Determination 2017/011

Regarding the refusal to issue an amendment to a building consent for repairs and repainting of the AAC cladding system of a 4-year-old house at 4126/6 Hampden/Palmerston Road, Moeraki

Figure 1: Typical vertical control joint

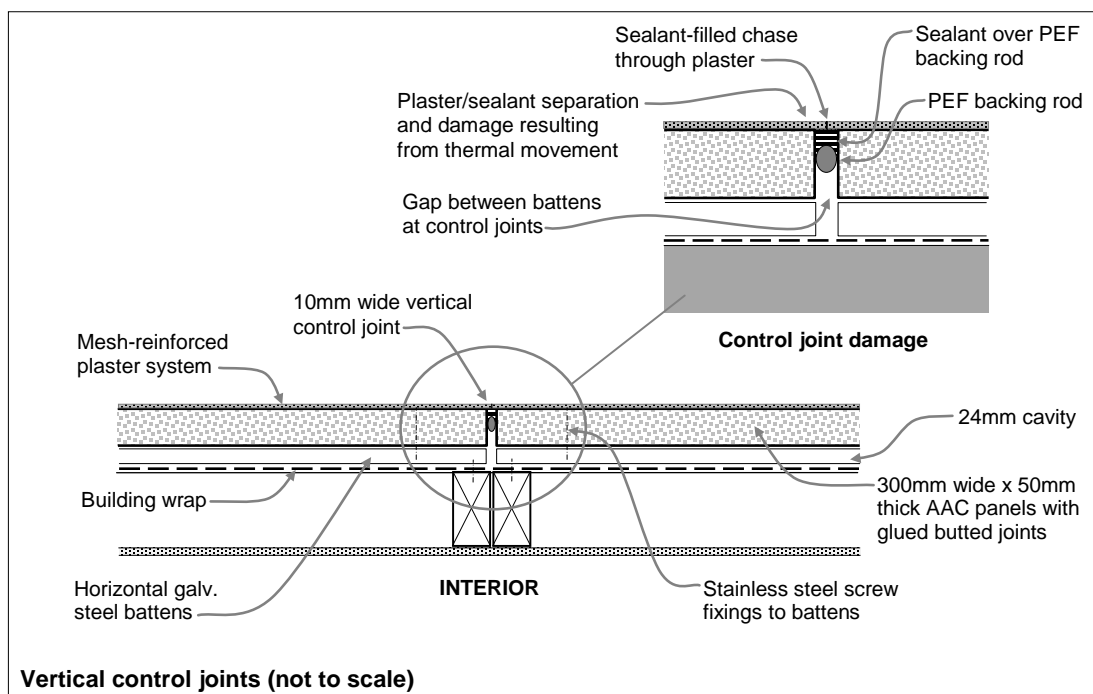
- 5.2.2 The expert inspected the 26 vertical control joint locations (see Figure 1), 14 internal corner junctions and wall sections with adhered joints, observing:

- 20 of the vertical control joints were uniform and without defects
 - 6 joints showed minor 'disruption' to the sealant joint ("the disrupted joints"), but no evidence of moisture migrating down to the base of the joints

- there was no evidence of movement at adhered joints
 - 'very minor' movement to the control joint above the junction of the wardrobe lean-to roof with the south wall of the master bedroom was evident, which appeared to have resulted from thermal movement of the apron flashing

- the above confirmed that excessive thermal movement was limited to designed control joints, with minor damage evident at only 6 locations.

- 5.2.4 The expert also carried out invasive investigation of five of the disrupted joints by cutting back a small area of plaster to observe the underlying control joint, and noted:

- thermal movement of the joint had disturbed edges of render above the joint
 - underlying joint widths were 10mm, which is in accordance with instructions

- cutting and lifting sections of sealant revealed PEF backing rods in place
 - sealant appeared well adhered with no separation observed.

...minor targeted repair to 6 control joints only and a paint colour change undertaken by a suitably qualified LBP trades person.

5.3.3 The expert considered that the repairs and repainting proposed by the applicant and described in the garage plasterer's quotation, followed by a producer statement for that work, would 'repair the joint sealant damage caused by the investigations and provide an appropriate repaint to the AAC claddings.'
